RE DOE CONTRACT N16459

**Response to Comments by Kristen Schwab on *Calibration of Tritium Release Rates to Vadose Zone and Ambient Air Measurements for the U.S. Ecology Low-Level Radioactive Waste Disposal Facility, Richland Washington***

**June 13, 2008**

## Calibration of Tritium Release Rates to Vadose Zone and Ambient Air Measurements for the U.S. Ecology Low-Level Radioactive Waste Disposal Facility, Richland Washington

**Figure 3.** Tritium concentration in condensed water vapor measured in the vadose zone wells from 1996 to 2006. The background concentrations measured in well VW100 are fairly stable.

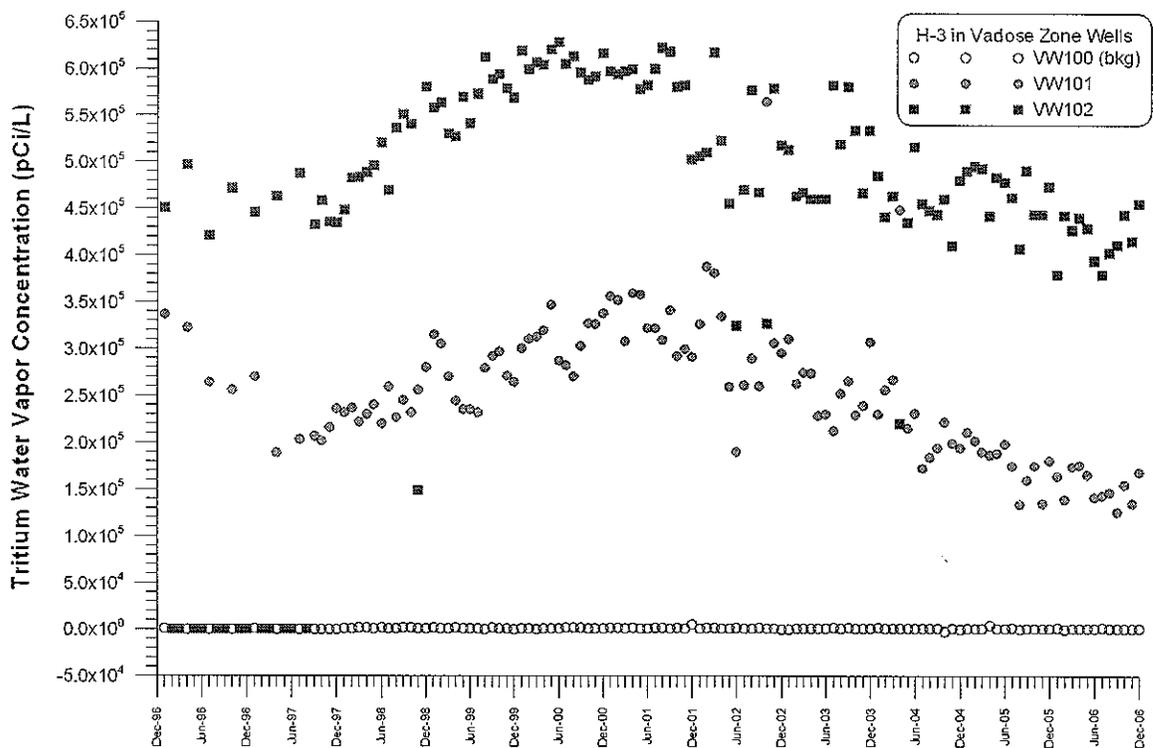
**Figure 3. Could you use different colors for the symbols? It is hard to distinguish the shades of red from each other**

**RESPONSE:** I changed the symbol size and the colors on Figures 3-4 and 6-7.

**Figure 6.** Predicted and observed tritium concentrations in vadose zone pore water. Measured concentrations are from the vadose zone monitoring wells.

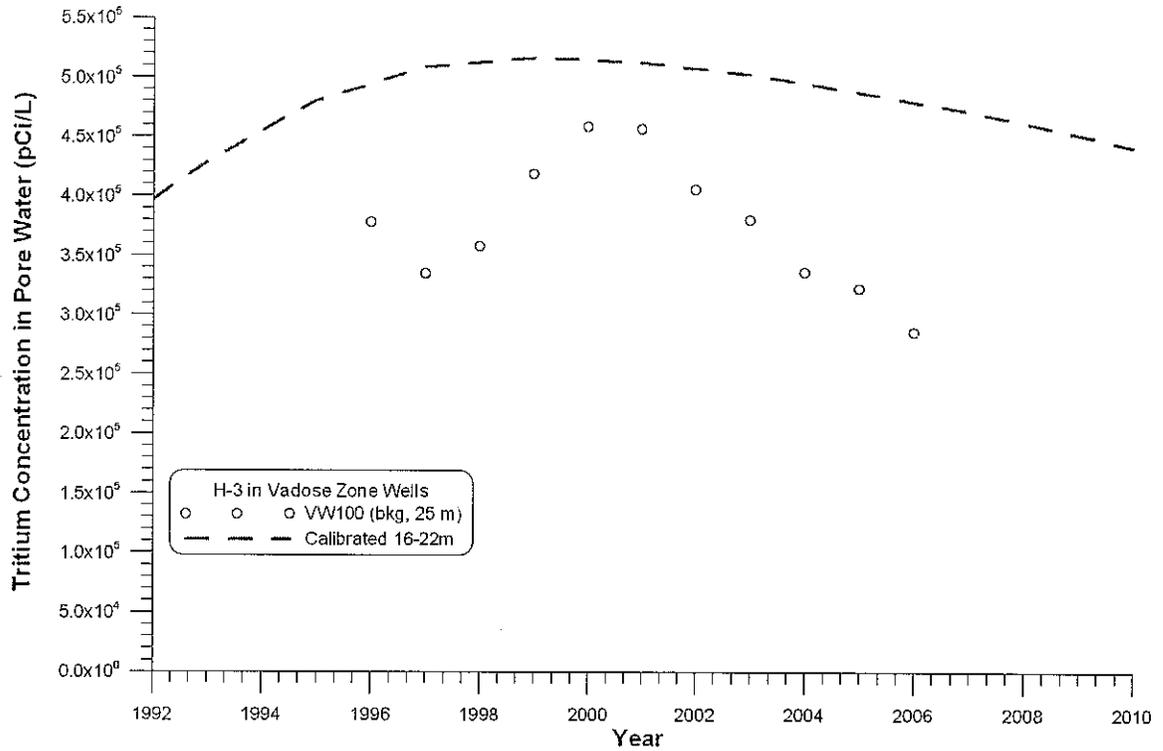
**Figure 6. Since the concentration of tritium increases as the depth approaches 20 m shouldn't the calibrated concentrations for 16-22 m be greater than that for 10-16 m?**

**Page 18 and 19. The calibrated concentration of 0-10m looks like it is about 7.5e4 pCi/l, not the predicted value of 5970 pCi/L as given in the discussion on page 18.**

**RESPONSE:** Technically, yes, but the model does not have the spatial resolution to resolve the 3 m difference between the different measurement depths because the minimum layer thickness was about 6 m. Moreover, I have changed the comparison to observed values to reflect the spatial averaging that the model is based on (see next comment).

**RESPONSE:** The calibrated value of 5970 pCi/L represent the average predicted concentration from January 1996 to December 2006. In response to your comment, I have made extensive changes to the figures and text. Because the model represents a spatial average across the site, I

performed some spatial averaging of the measured data. I also averaged temporally across each year for comparisons with the predicted data.

Figure 10. Drinking water dose as a function of time for CASE1 with the enhanced cover, closure in 2056, and calibrated tritium release rates.

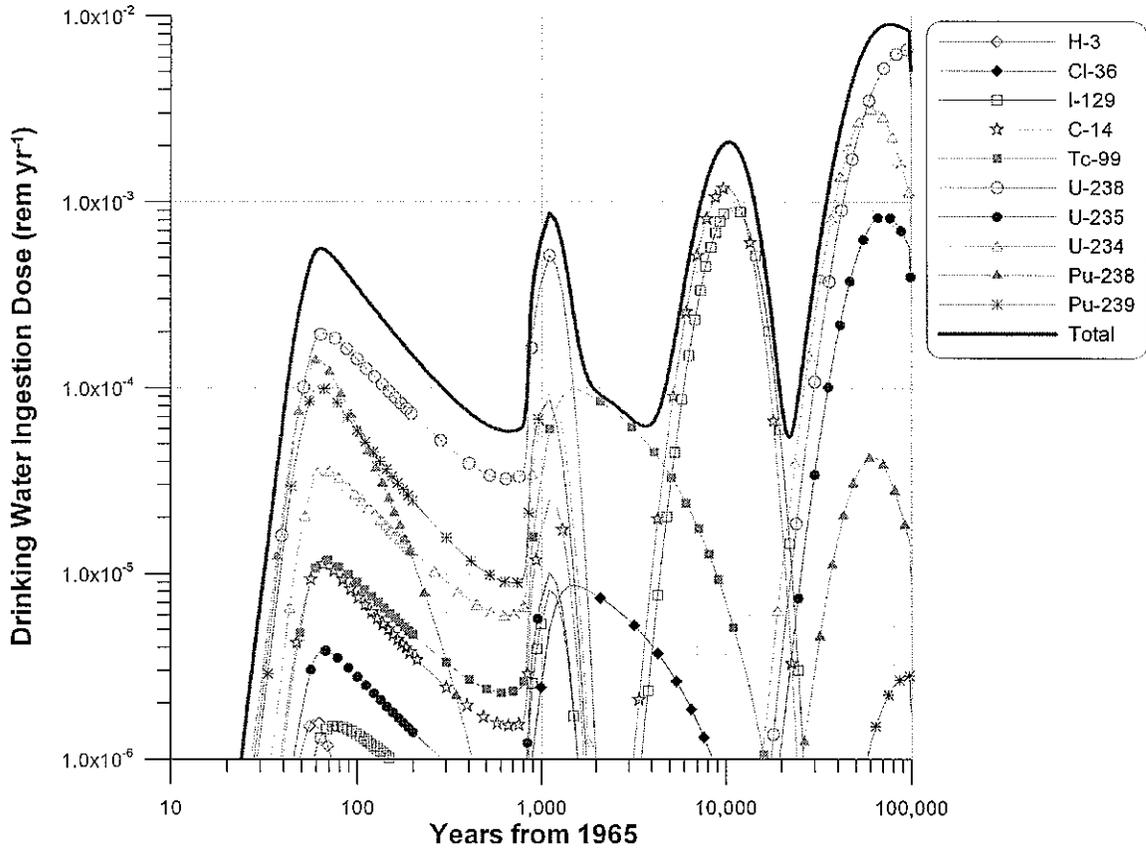
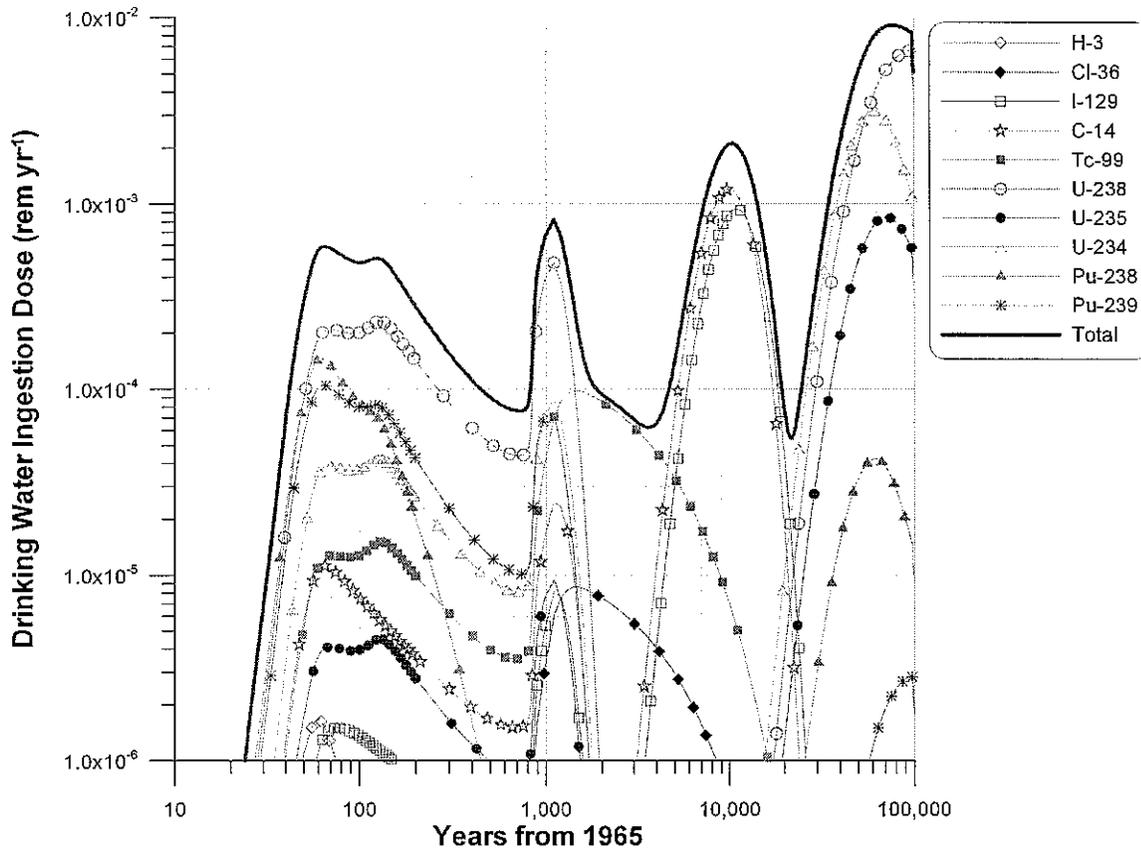
**General Comment: Are there conclusions for CASE 2?**

**RESPONSE:** I have included a graphs and a comparison of the original CASE1 and CASE2 drinking water dose and the drinking water dose with the calibrated tritium releases.
